Levy Nuclear Plant Units 1 and 2
Response to NRC Request for Additional Information Letter No. 101 Related to
SRP Section 2.4.6 for the Combined License Application, dated February 28, 2011

NRC Letter No.: LNP-RAI-LTR-101

NRC RAI NUMBER: 02.04.06-17

PGN RAI ID #: L-0902

FIGURE 2.4.6-230

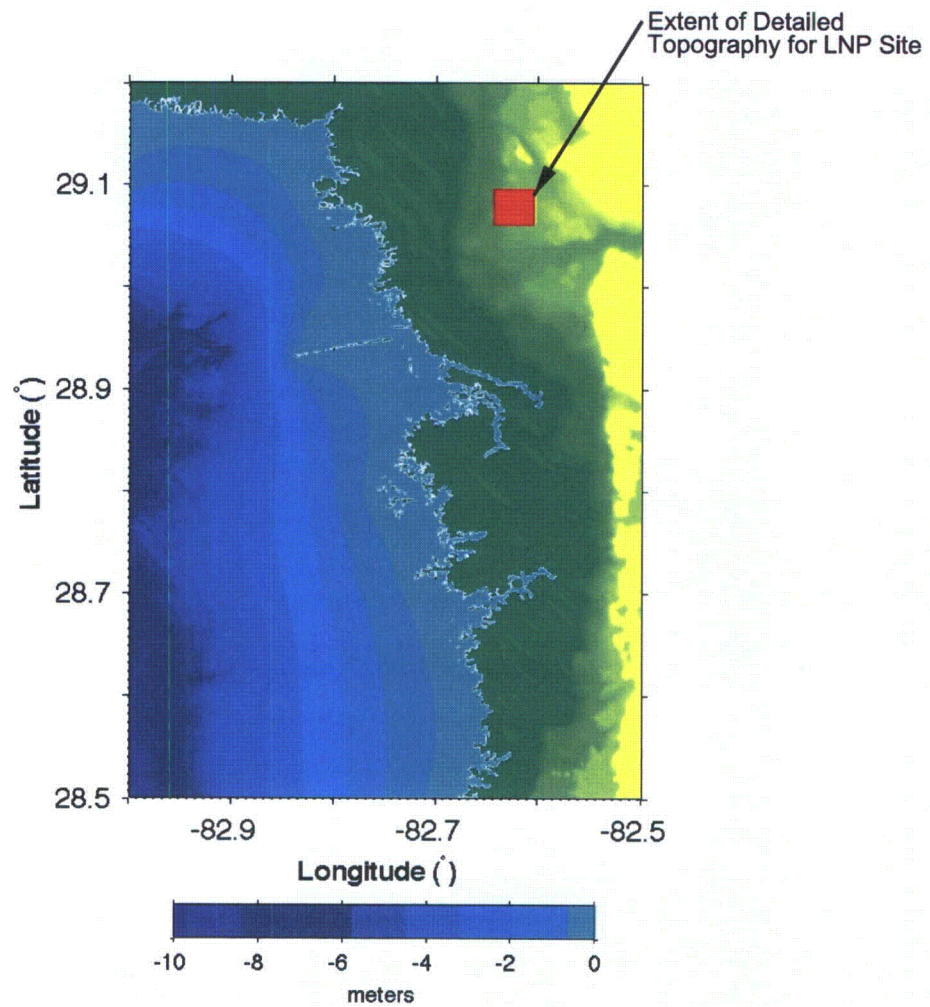
- (4) Provide the geographic location (lat, long) and water depth where the shoaled amplitude A(R) in Table 2.4.6-207 is calculated.
- (5) Provide location information for revised figure 2.4.6-230 "Landward Topographic Profile," for example, in a map figure.

10. FSAR Figure 2.4.6-229 will be replaced with new Figure 2.4.6-229 as presented in Attachment RAI 02.04.06-17-C.
11. FSAR Figure 2.4.6-230 presented in response to NRC Letter 094, RAI 02.04.06-16 (NPD-NRC-2010-083, L-0867) will be replaced with new Figure 2.4.6-230 as presented in Attachment RAI 02.04.06-17-C.
